10/502,015

Hiroo Matsunaga

<p align="center"><b>Advisory Action</b> <b>Before the Filing of an Appeal Brief</b></p>	<b>Application No.</b> 10/502,015	<b>Applicant(s)</b> MATSUNAGA, HIROO	
	<b>Examiner</b> Steven D. Maki	<b>Art Unit</b> 1733

FIG. 1

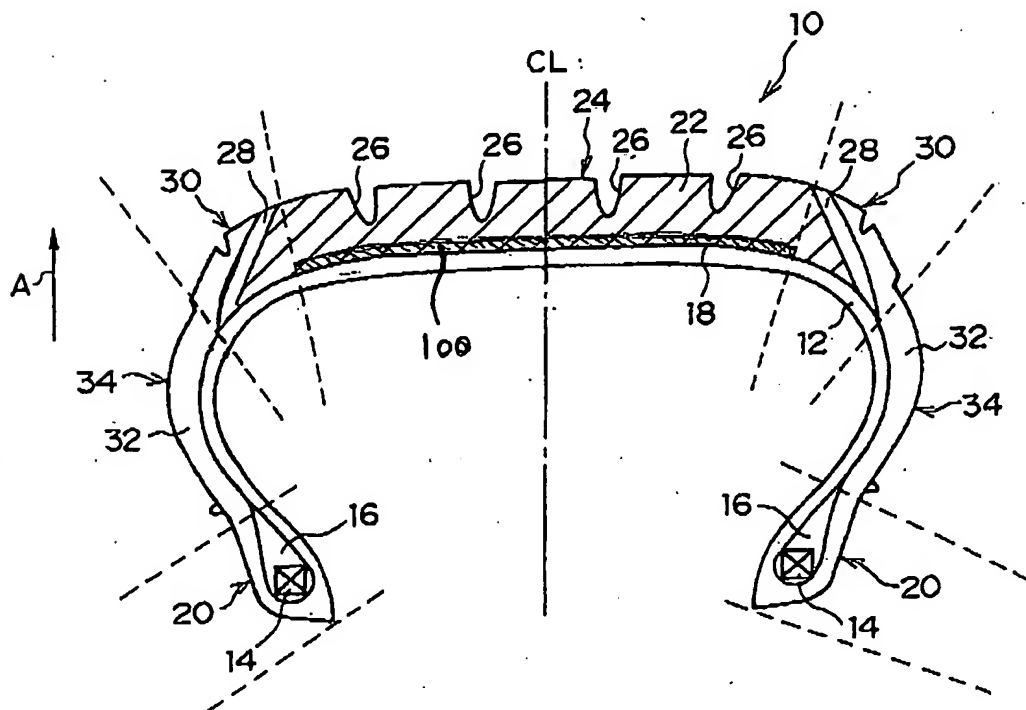
- (1) in the drawings, adding illustration of "belt 100" to Figure 1 and in paragraph 5 on page 15 of the specification, changing "belt (not shown)" to --belt (see Fig. 1 - element 100)--;
- (2) in claim 1, changing "said tread rubber, said side rubber and said side wall rubber are attached directly to the carcass," to --a central portion of said tread rubber is attached to the carcass via a belt, a side portion of said tread rubber, said side rubber and said side wall rubber are attached directly to the carcass on the outer side of the carcass in the radial direction of the tire--; and
- (3) in claim 1, deleting --entirely-- without adding appropriate language such as "the interface between the side rubber and the side wall rubber appears at the ground contacting side of the tire" (specification page 22).

- (1) in the drawings, adding illustration of "belt 100" to Figure 1 and in paragraph 5 on page 15 of the specification, changing "belt (not shown)" to --belt (see Fig. 1 - element 100)--;
- (2) in claim 1, changing "said tread rubber, said side rubber and said side wall rubber are attached directly to the carcass," to --a central portion of said tread rubber is attached to the carcass via a belt, a side portion of said tread rubber,

DO NOT ENTER  
Jm 2-1-07
